IN THE DRAWINGS

FIG. 1

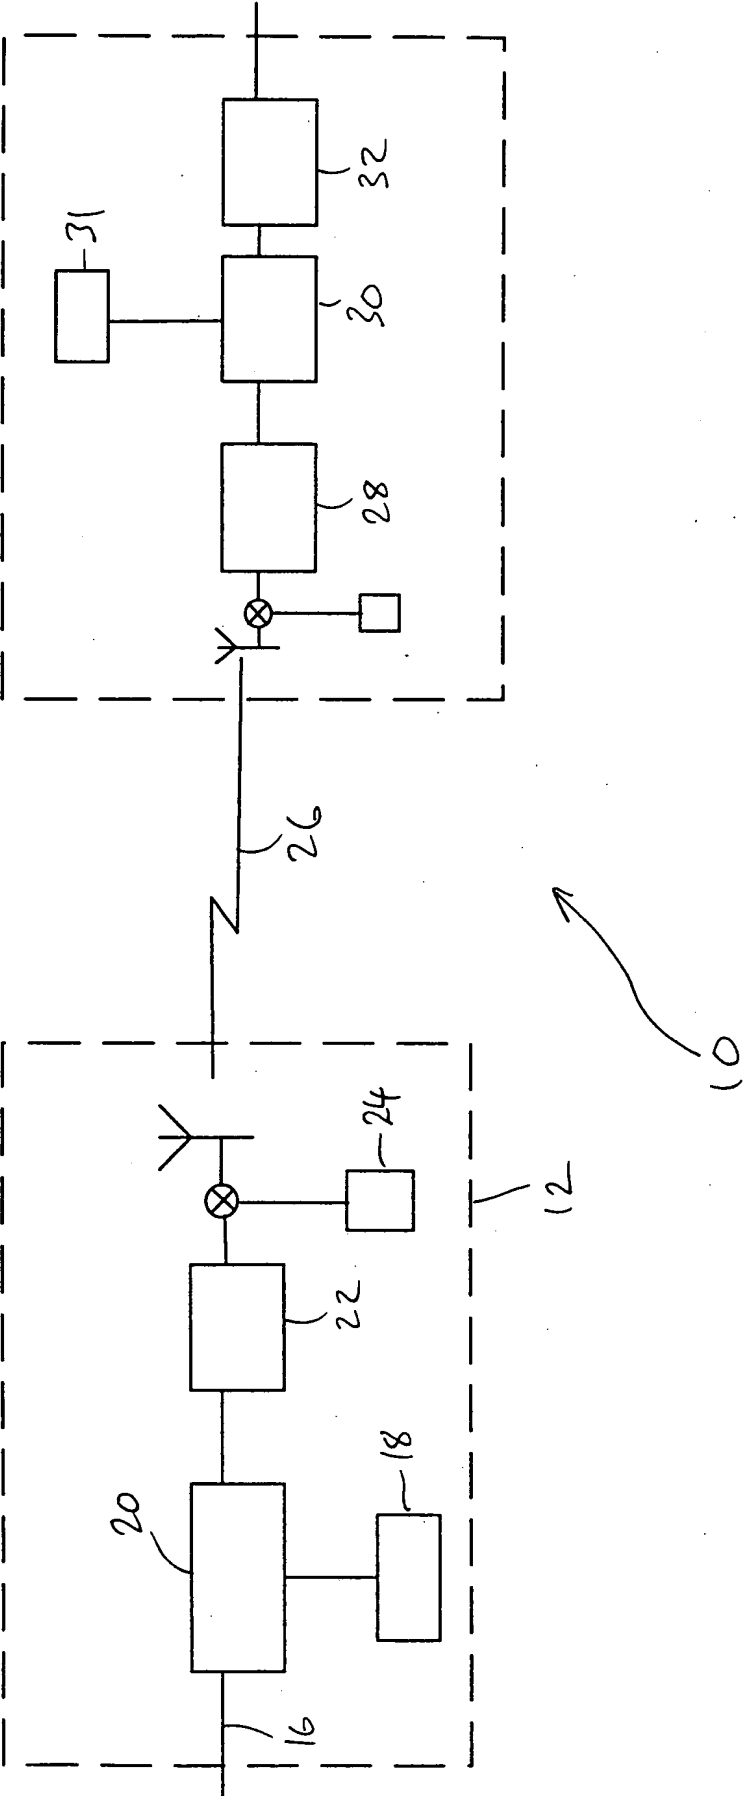
The Examiner objected to the drawings in the Final Office Action dated January 9, 2004. Specifically, the Examiner stated that reference numerals 16, 20, 22, 18, 24, 28, 30, 31, and 32 require labels as described in the specification. Figure 1 has been amended and the labels requested by the Examiner have been added. Applicants have attached Figures 1-3 for the Examiner's approval. No new matter has been added as a result of the amendments to the drawings.
